Approval of SWSP Renewal Request for the East Rigden Pit (M-1979-097, Plan ID 3055)

**Re: City of Fort Collins East Rigden Pit Substitute Water Supply Plan
(WDID 0302570, Plan ID 3055)
DRMS File No. M-1979-097 (WDID 0303021)
Sections 21, 27 & 28, T7N, R68W, 6th P.M.
Water Division 1, Water District 3, Larimer County**

Approval Period: July 1, 2021 through June 30, 2022
Contact information for Mr. Shuler: 303-806-8952; jshuler@bbawater.com

Figure 1
East Riden Pit
Pre-1981 and
Expanded Pond Extents

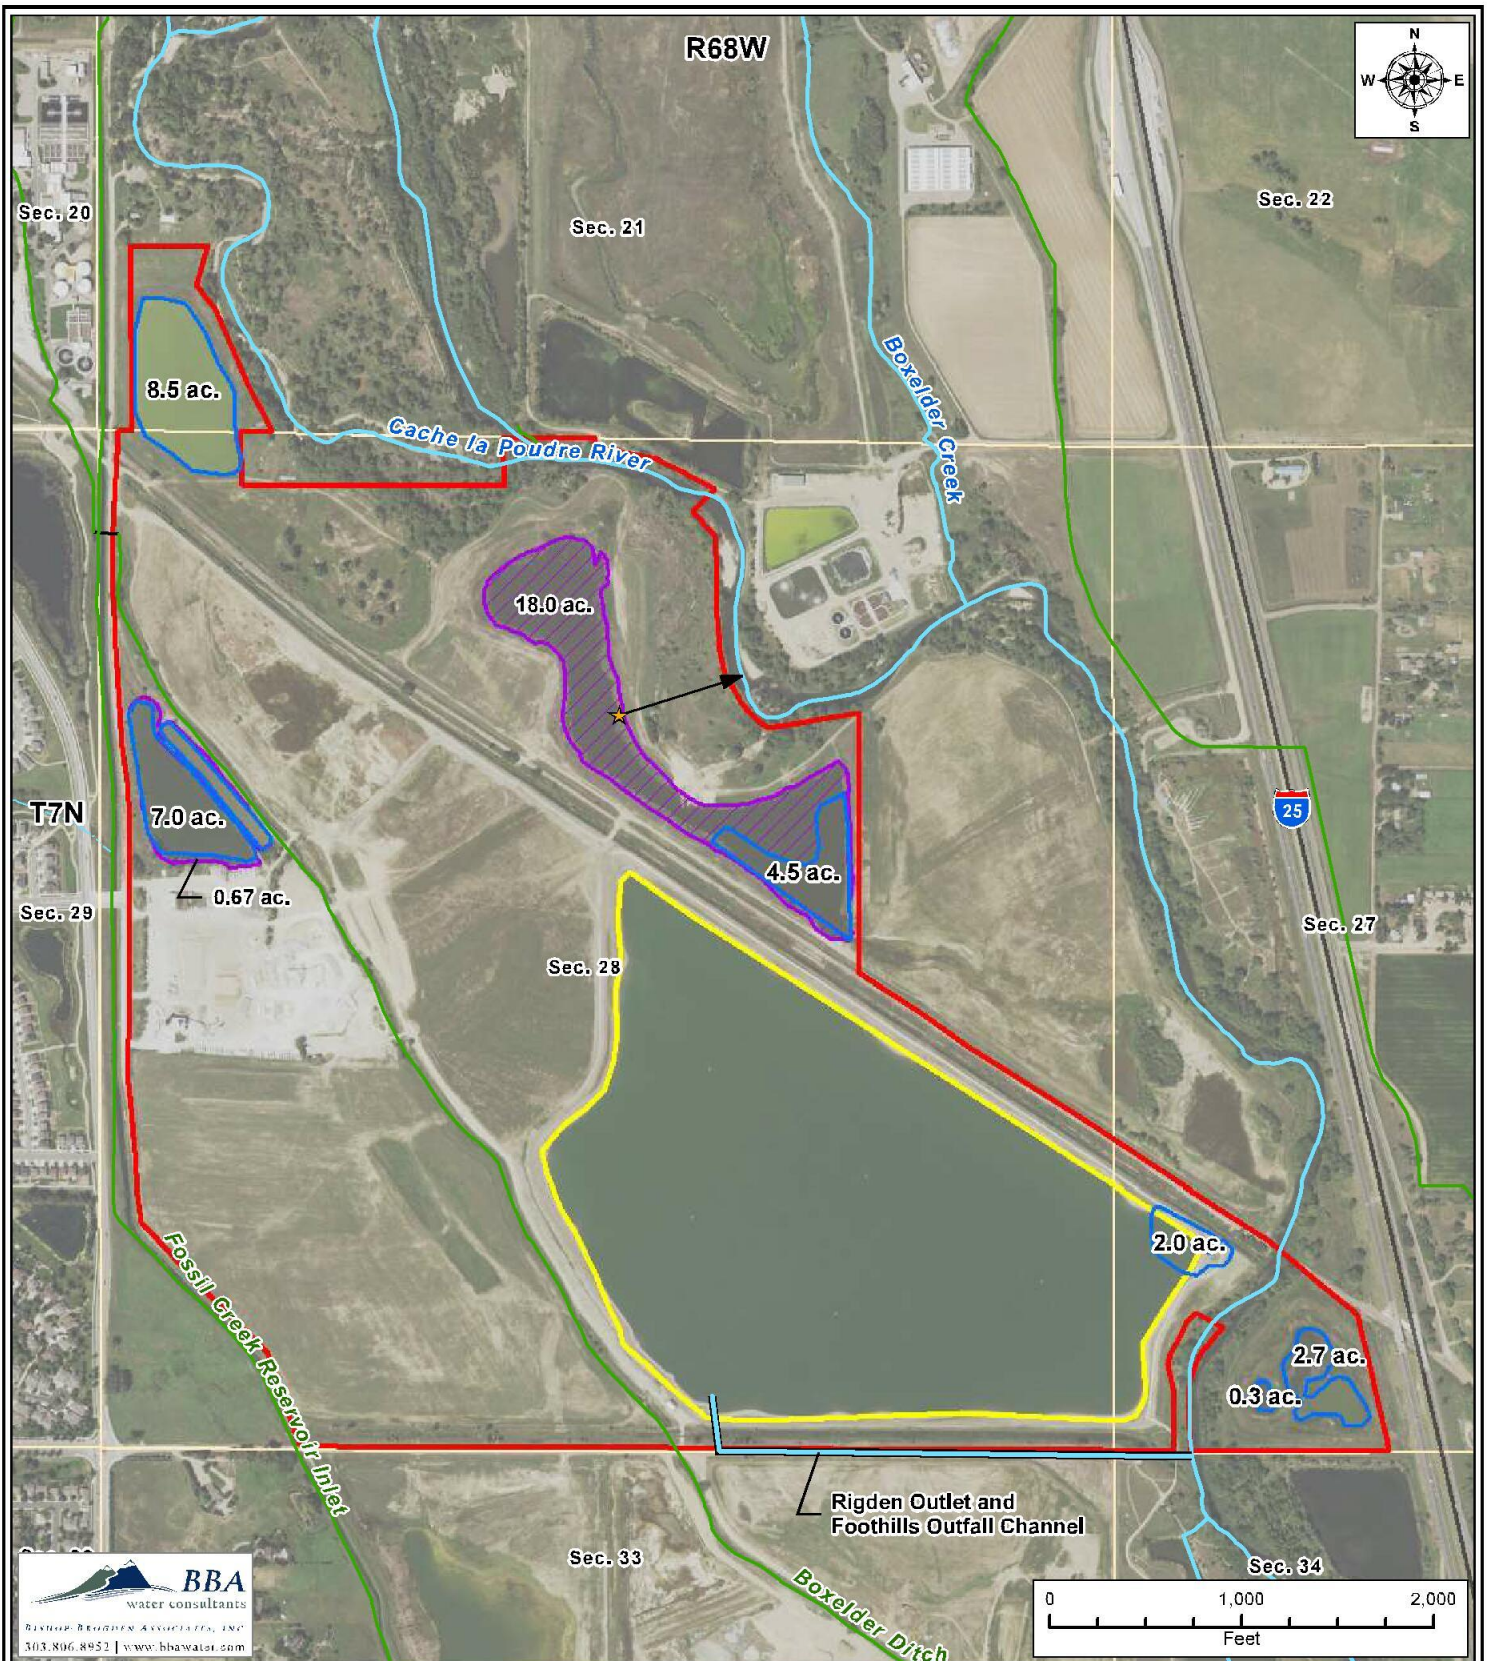
The East Rigden Pit is located along the Cache la Poudre River in Sections 21, 27, and 28, Township 7 North, Range 68 West of the 6th P.M., as shown on the attached Figure 1. Sand and gravel mining exposed groundwater at the pit site but according to a January 2019 inspection report from the Division of Reclamation, Mining and Safety ("DRMS") the area has not been mined in many years. The 2015-2016 SWSP determined that all 25 acres of groundwater exposed at that time were documented as having been exposed at the site prior to January 1, 1981. Pursuant to section 37-90-137(11)(b), C.R.S., and case no. 2009CW49, a gravel pit operator or property owner does not need to replace depletions that occur due to evaporation from groundwater exposed prior to January 1, 1981 ("pre-81") as a result of open mining of sand and gravel, regardless of whether mining continued after December 31, 1980. The pre-81 pond extents approved in the 2015-2016 East Rigden SWSP are shown in Figure 1, and may not be re-allocated to other areas of groundwater exposure within the gravel pit boundary. The 2015-2016 SWSP stated that with the SEO approval of the compacted clay liner in the Fort Collins Parcel, no depletions associated with the East Rigden Pit would remain after the conclusion of that plan period and no subsequent SWSP would be required for the site. However, a DRMS field inspection in January 2019 found that the acreage of the exposed groundwater had increased beyond the pre-81 extent. This additional exposed surface area is considered to have been exposed after December 31, 1980 ("post-80") and has been included in a substitute water supply plan since July 1, 2019. Fort Collins does not plan to conduct

The DRMS estimated the exposed groundwater surface area of the north, west, and northwest ponds to have expanded by 18, 0.67, and 0.38 acres respectively beyond the areas granted pre-81 status. DRMS estimated the acreage of the southeast pond to have decreased by 0.08 acres, however this decrease does not provide credit that can be allocated elsewhere. The Applicant agrees with the new acreage for the north and west ponds, but believes that the northwest and southeast ponds have maintained the extent of their approved pre-81 areas. The Applicant attributes the minor differences in surface area between that determined by DRMS and the prior mapping conducted by Applegate Group, Inc. to mapping accuracy discrepancies. This office conducted an analysis of currently exposed areas shown on aerial imagery and has found that the minor differences in surface area could be reasonably attributed to mapping accuracy discrepancies and accepts the Applicant's proposal to maintain the extents of the area of the northwest and southeast ponds as were approved in the 2015-2016 SWSP. Therefore, the total post-80 surface area is considered to be 18.67 acres for this plan period.

3. The total surface area of the post-80 groundwater exposed at the East Rigden Pit site must not exceed 18.67 acres, which results in an annual net evaporative loss of 44.19 acre-feet.
